Universal Tractor Canopy Latch Hardware Replacement

p/n: 9SV-HWK-00138

INSTALLATION INSTRUCTIONS

Fig. 1 (Replace Latch Hardware with new hardware (longer bolts))

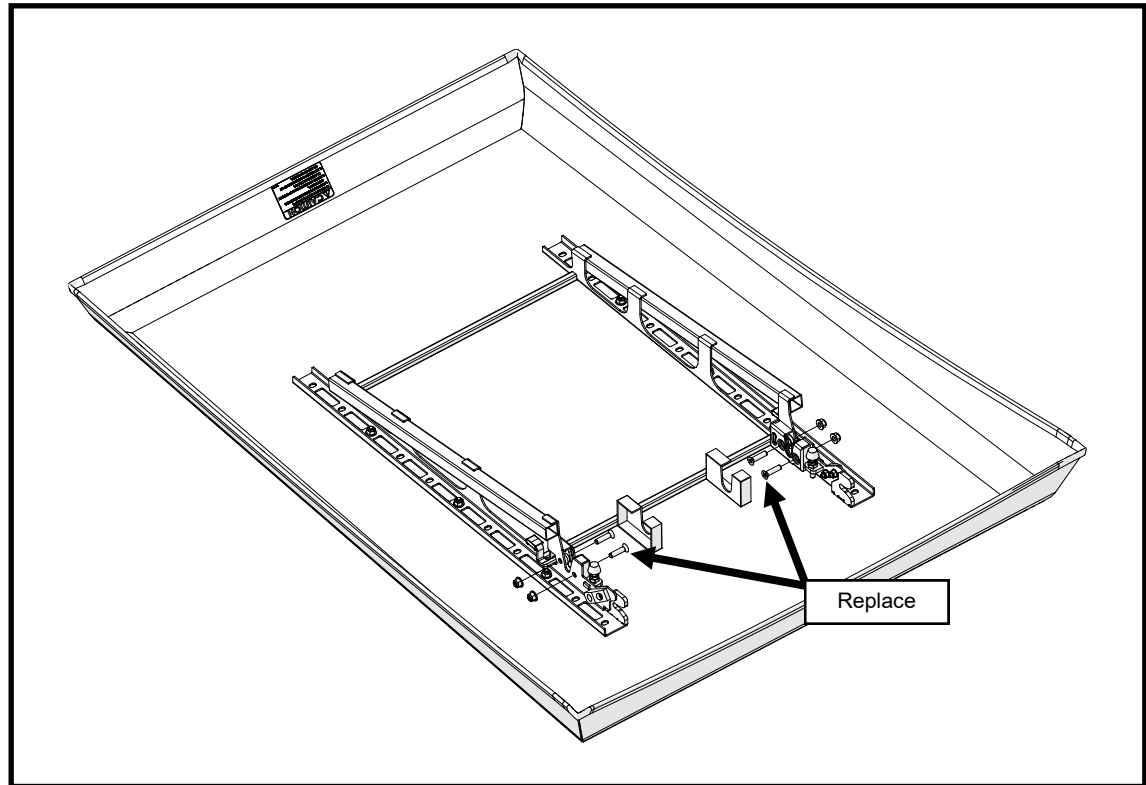
1. Remove canopy if it is attached to a vehicle and set it upside down on a soft surface to prevent scratching.
2. Remove the left plastic cover for the latch. See Figure 1.
3. Remove and discard the 5/16" Inch Series bolts and nuts and replace with the longer M8 Metric bolts and nuts provided in the kit. **Caution: threads are not identical. Make sure to set aside or discard 5/16" nuts so as to not mistakenly thread onto the M8 bolt and cause a cross-threading condition.**
4. Replace the plastic cover.
5. Repeat steps 2-4 on the right side.
6. Attach the canopy to the Striker Plate and verify the latches will double click. If not, adjust the bumpers accordingly.
